**Re: 703-723 W. Algonquin Rd – PUD Amendment – Amendment to PUD Ordinance 18-014 PC#20-016
– Round 3**

The following is our Planning Commission response Letter addressing the comments as outlined in the Village of Arlington Heights Building & Life Safety Department Interoffice Memorandum regarding the aforementioned project:

Planning & Community Development Dept. Review Round 2 Comments

Exhibit A

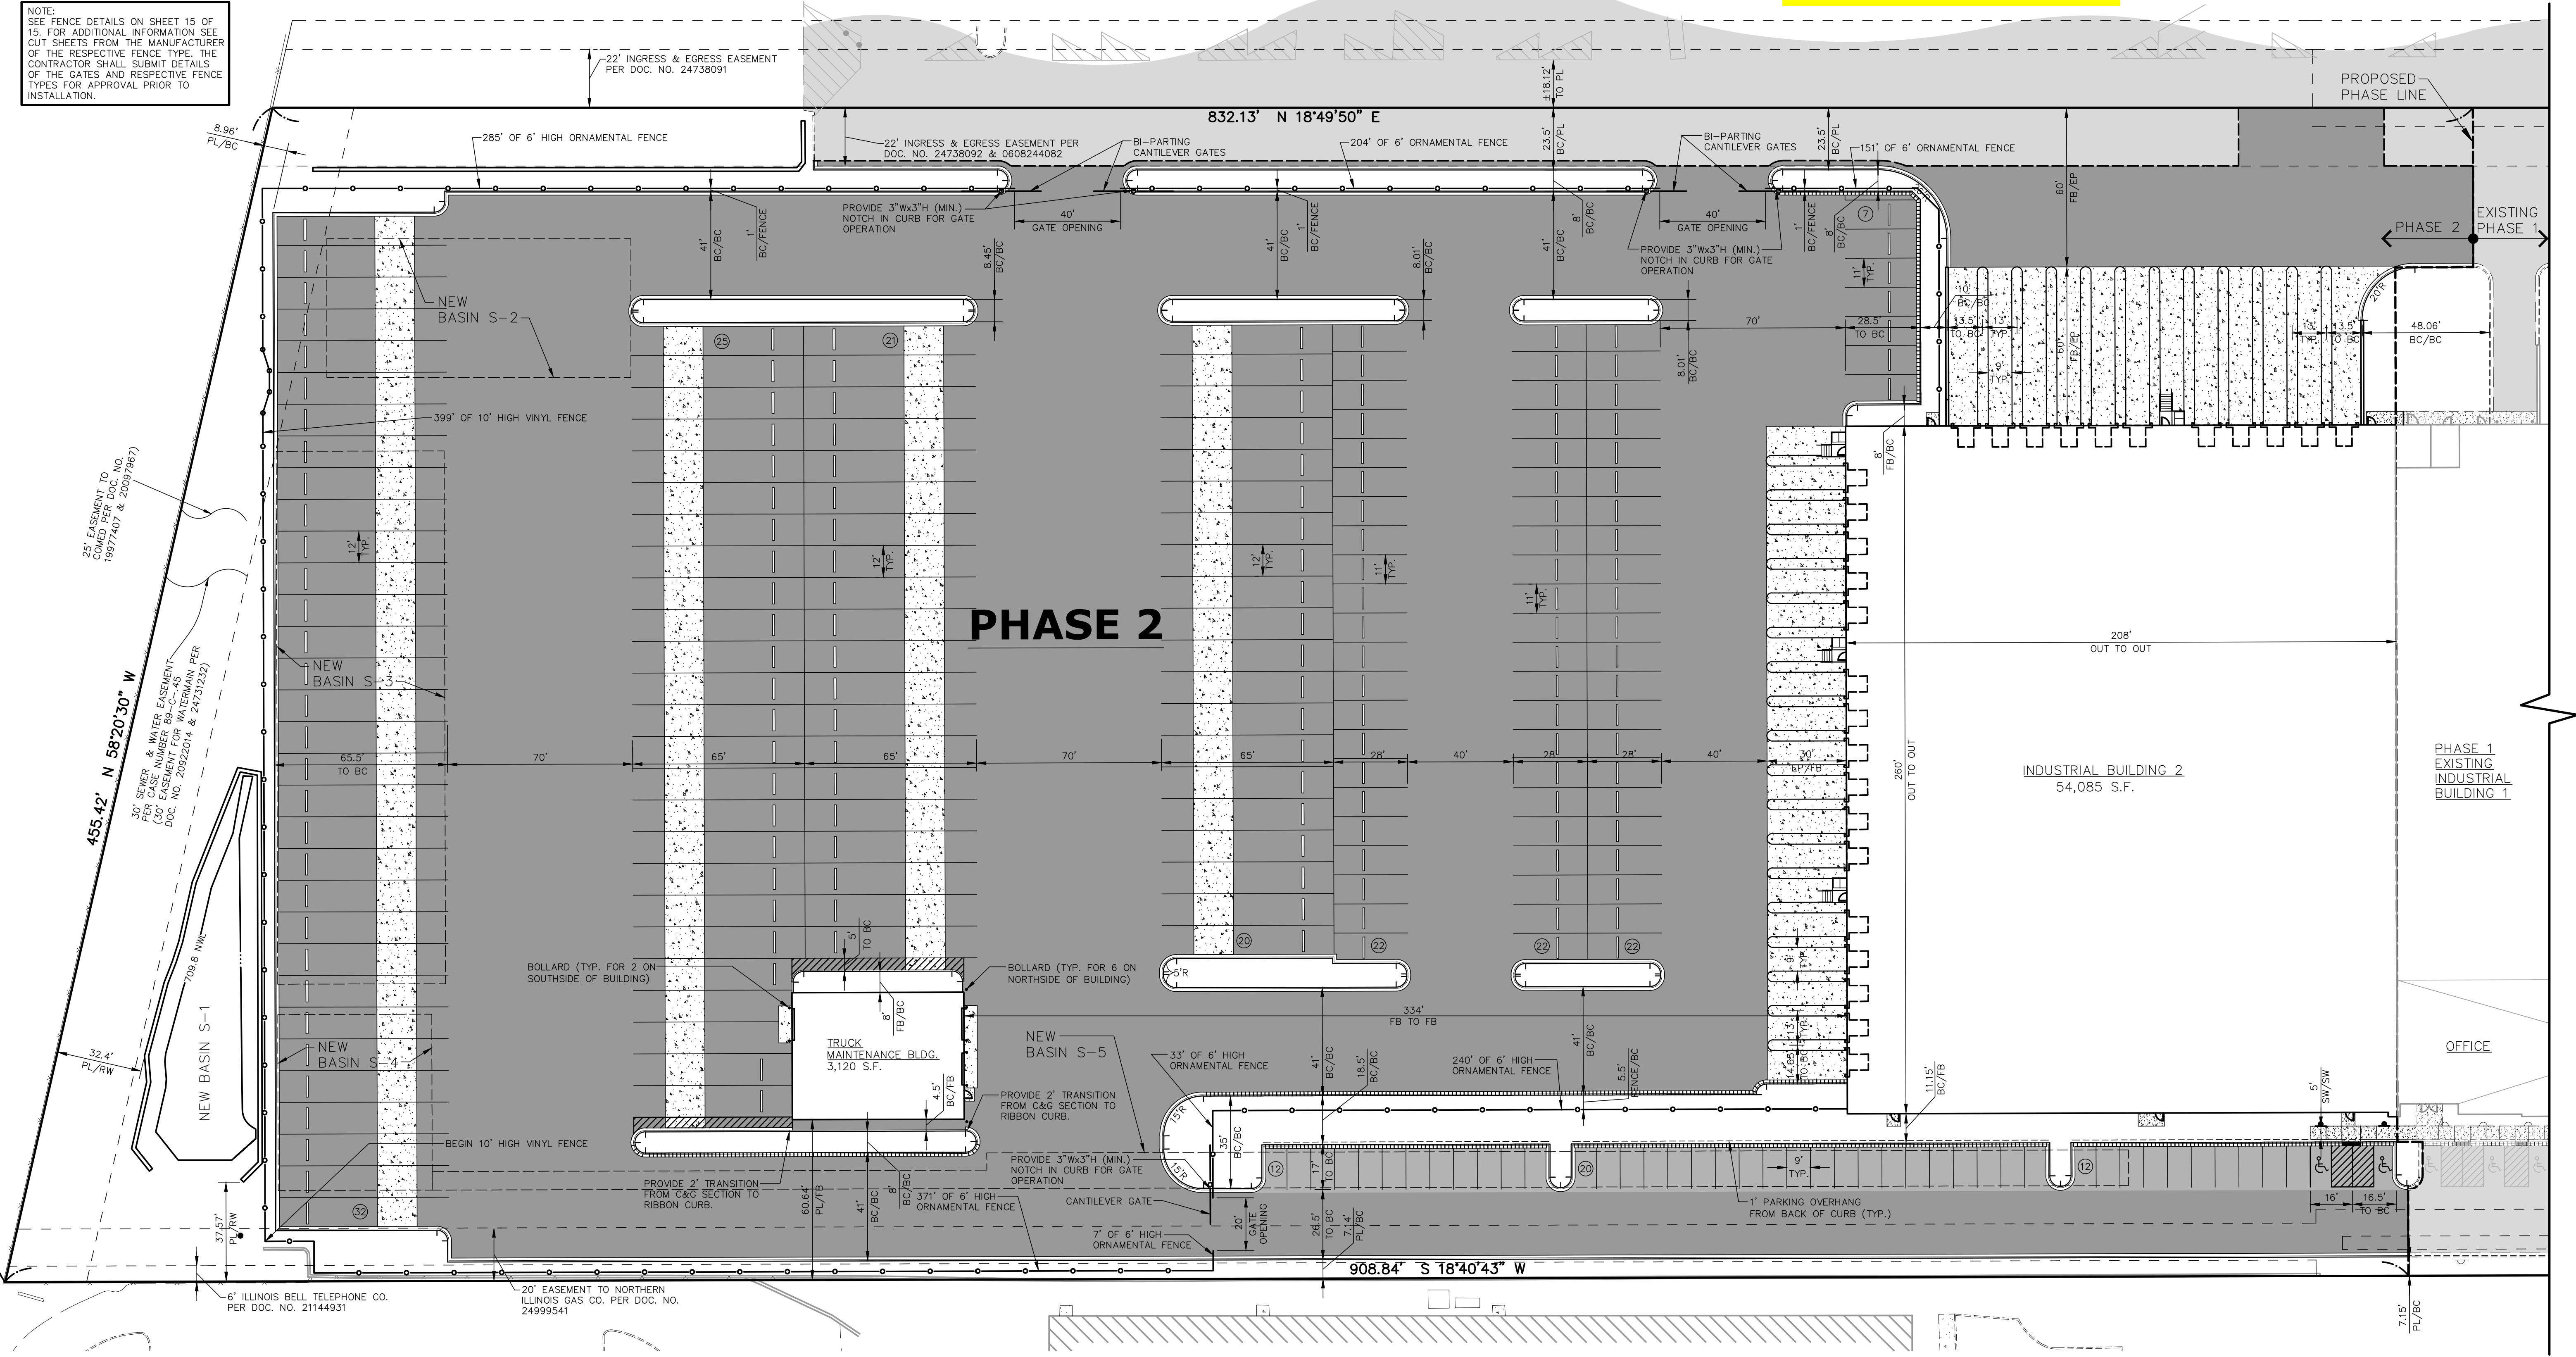
- a. Two additional landscape islands have been added that were requested.
- b. The fence has been shifted to the east to allow additional space for substantial landscape planting. (Exhibit A)
- c. Hedge link fence has been replaced with 6-foot ornamental fence/gates and 10-foot vinyl at southern property line. (Exhibit A)
- d. Parking totals reference (Exhibit G)

Exhibit B

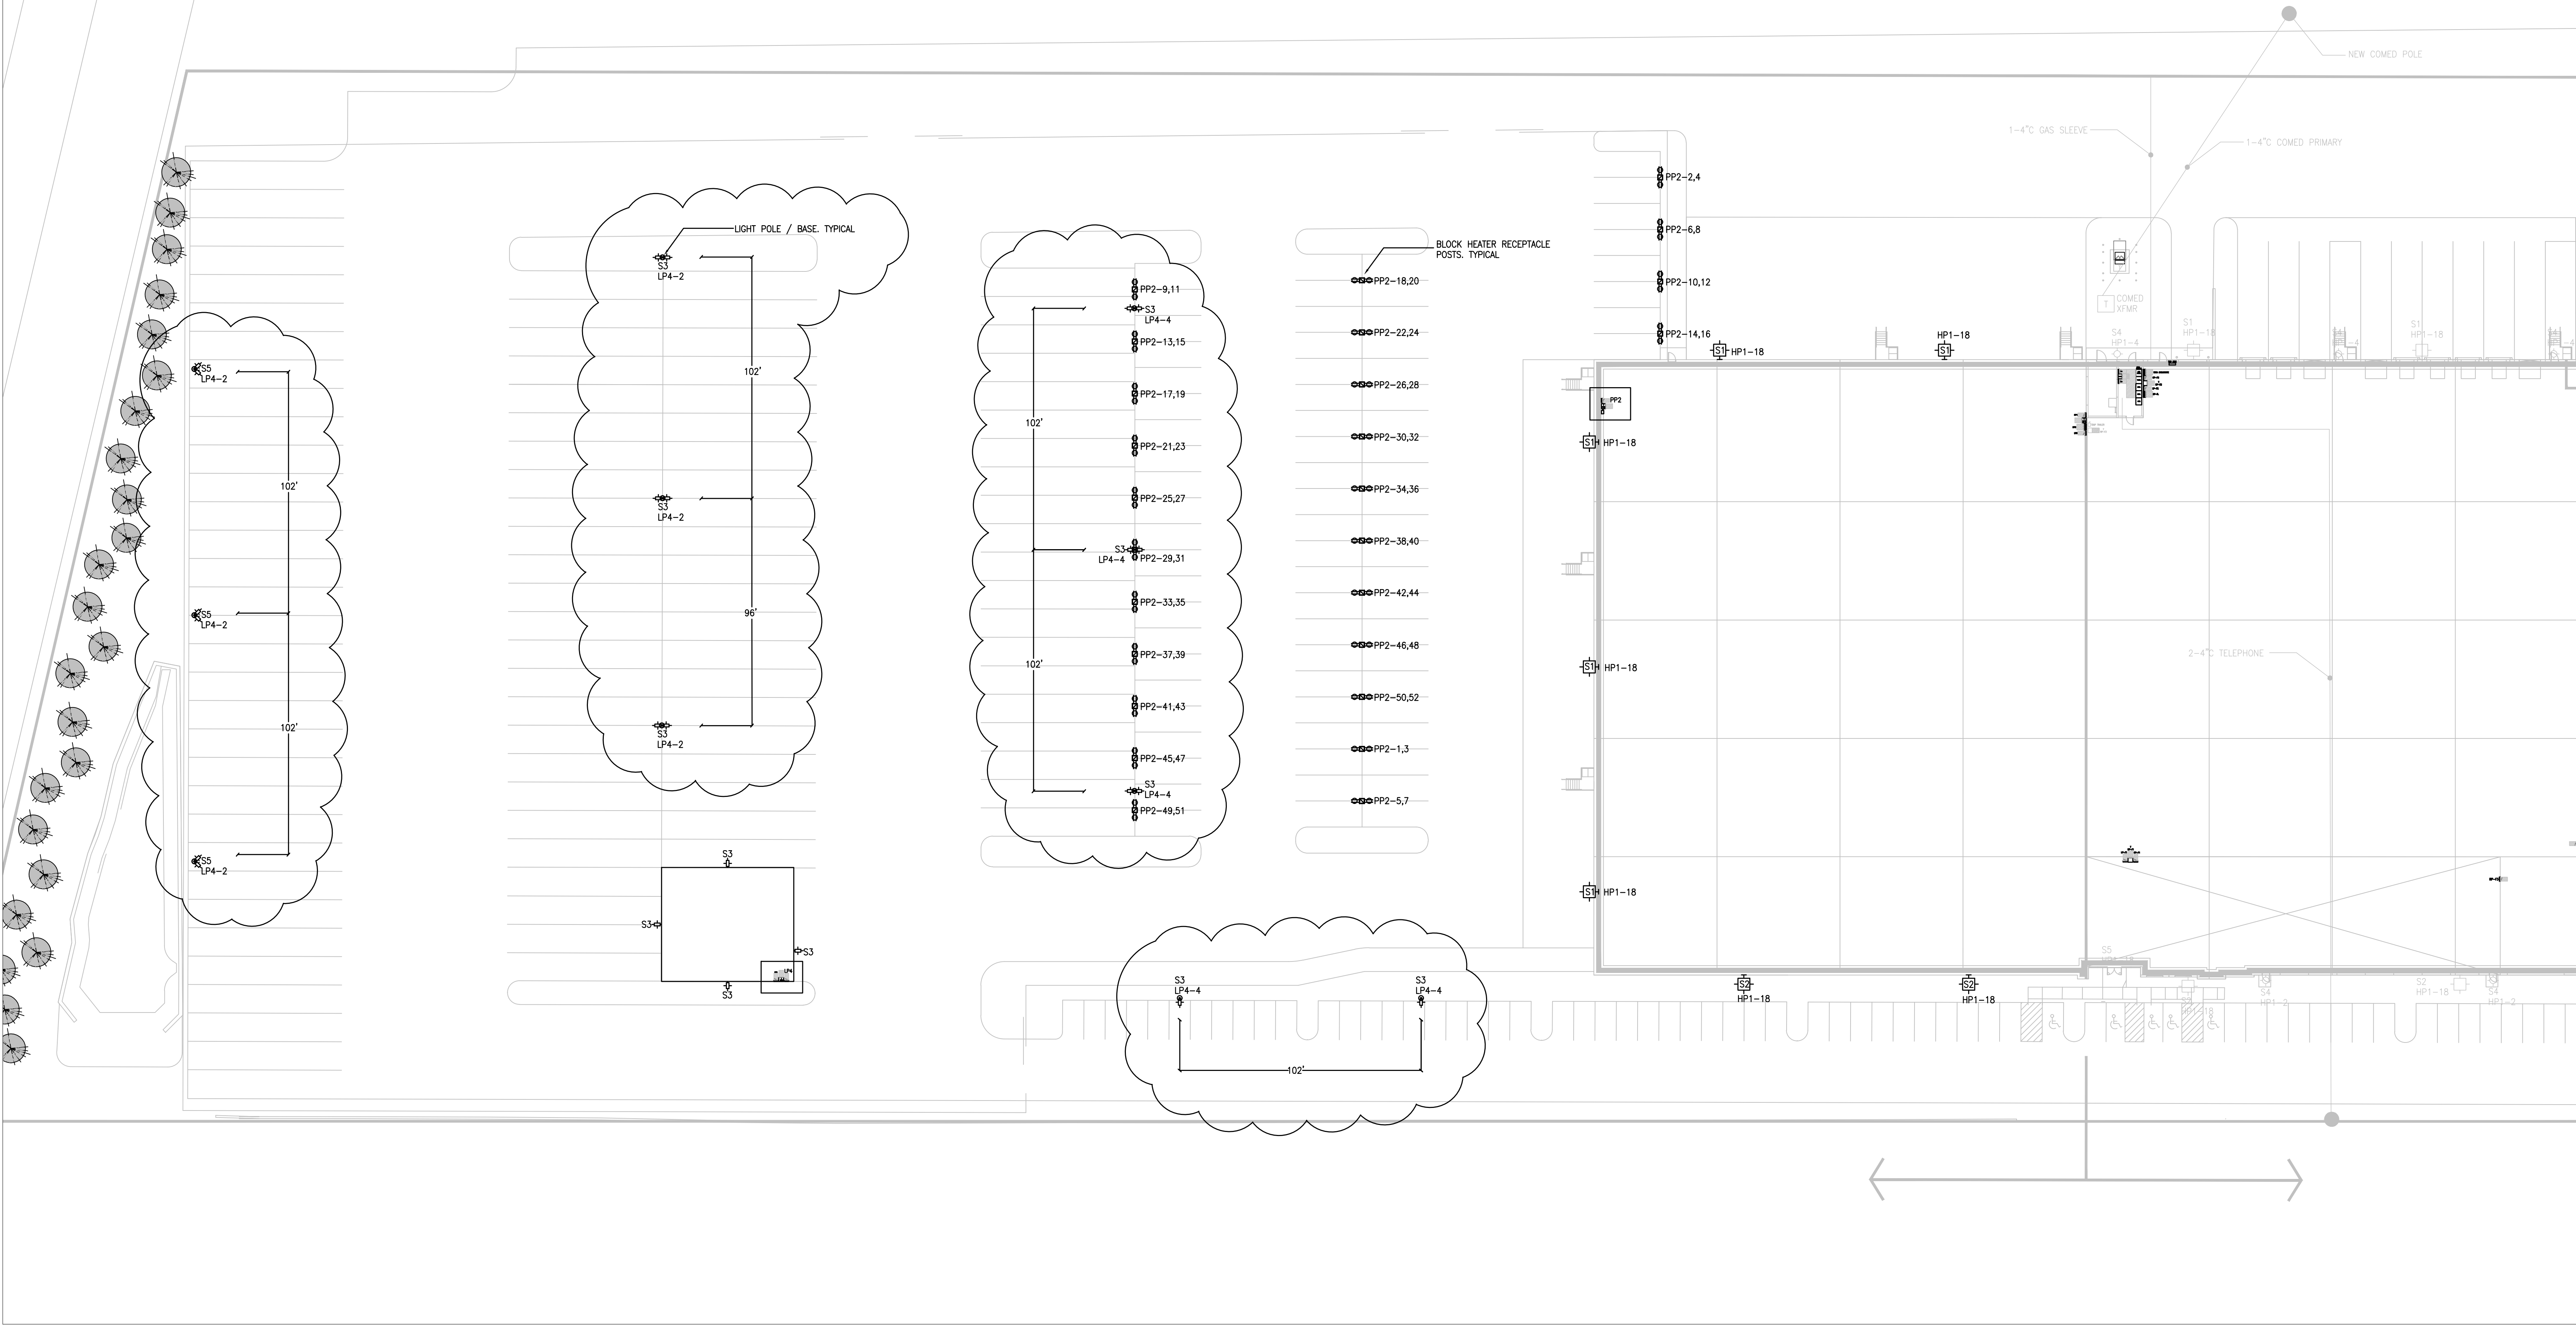
38. Response: Noted. Light Poles are to be spaced no more the 102' apart. Revised Site Lighting Plan (Exhibit B)

Exhibit C

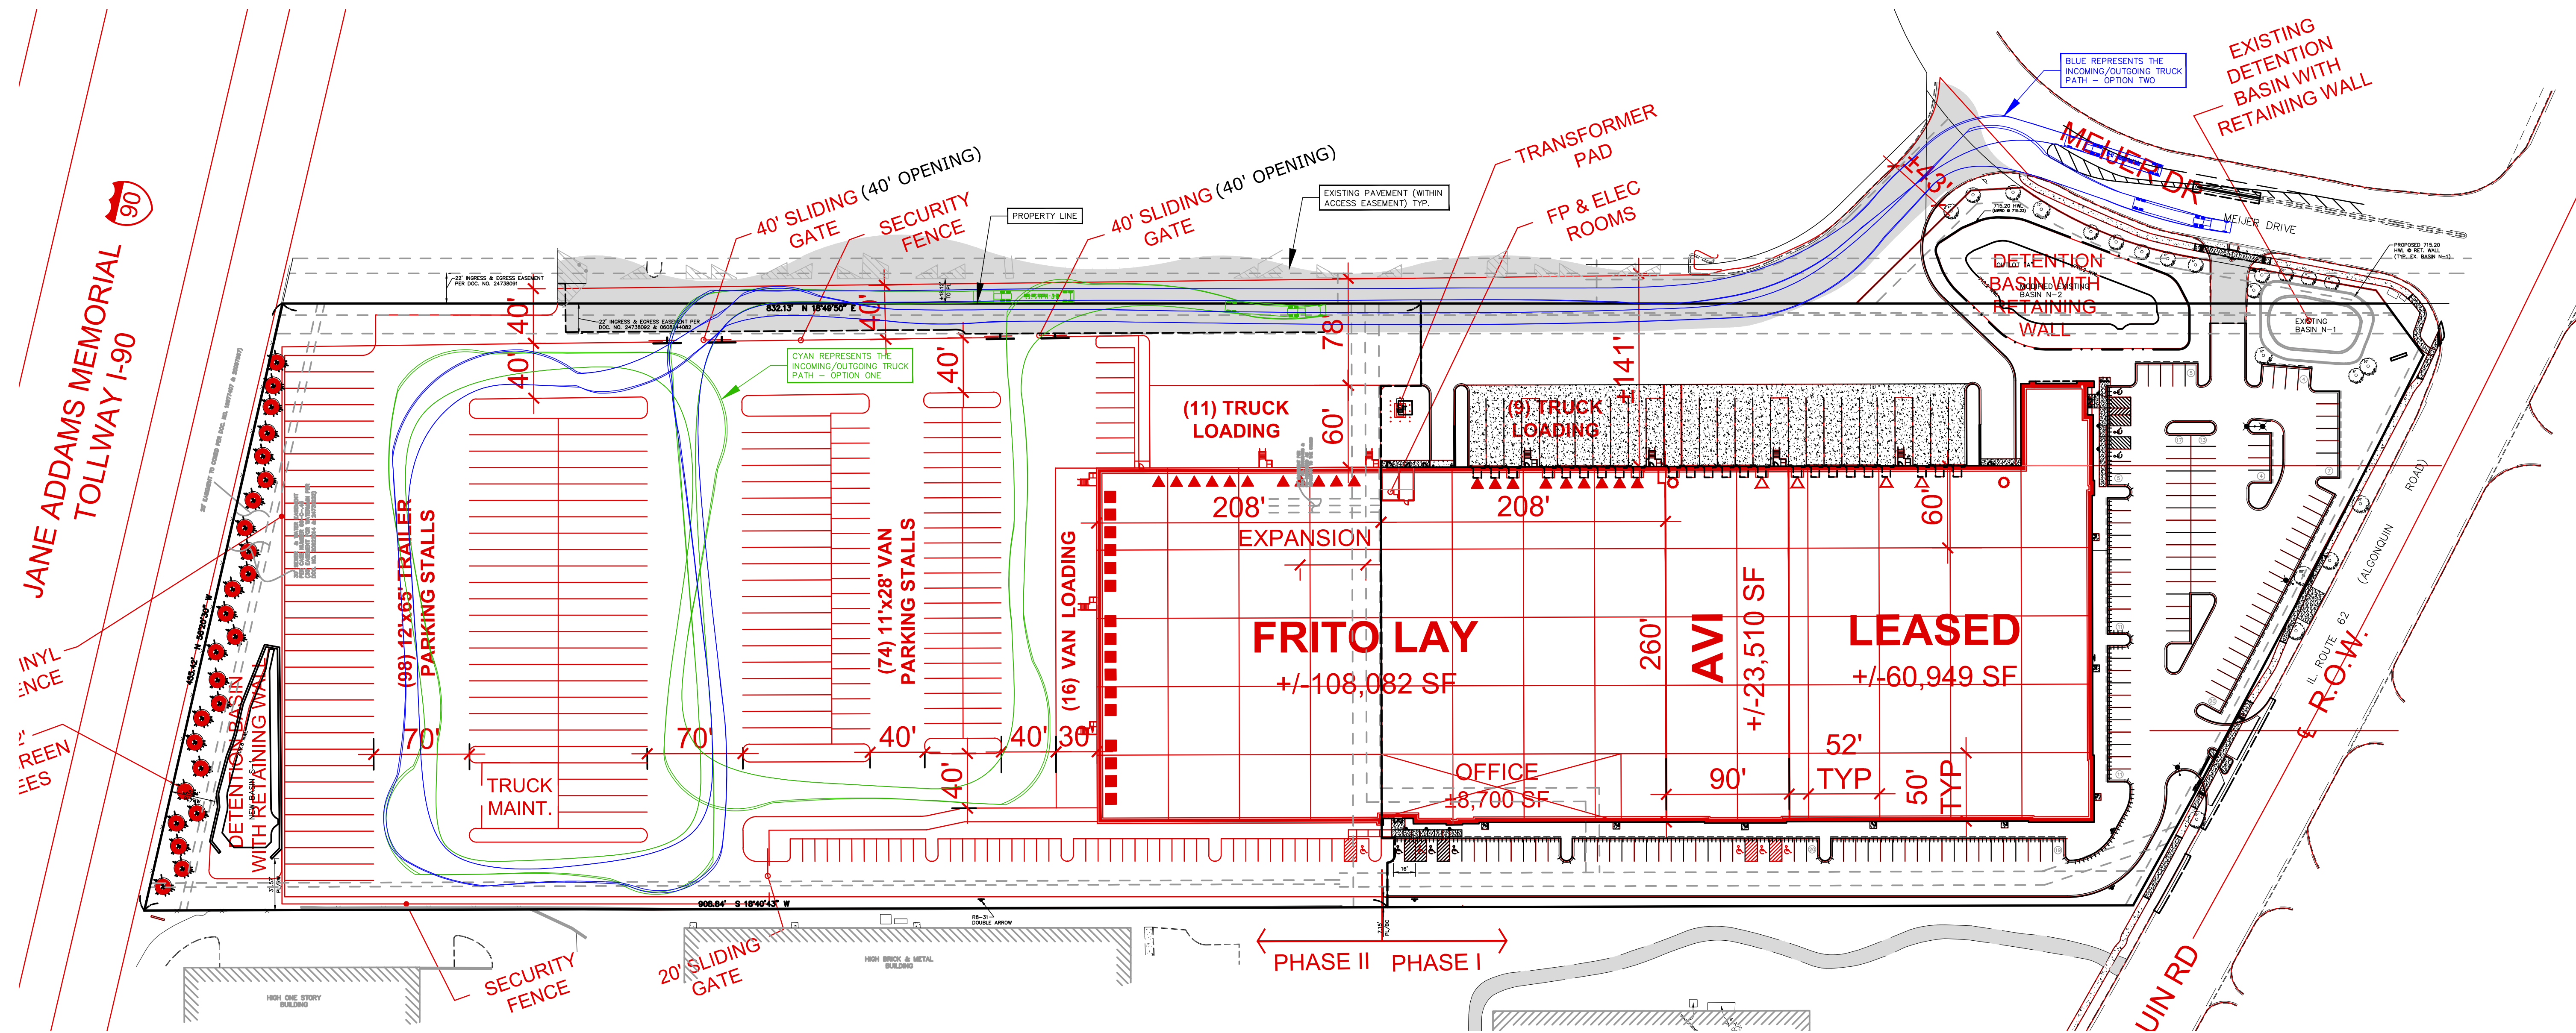
48. **Response:** Noted.
- a. **Response:** Yes, this gate will be restricted to trailer-trucks only
 - b. **Response:** Please see Truck Access Plan (Exhibit C)
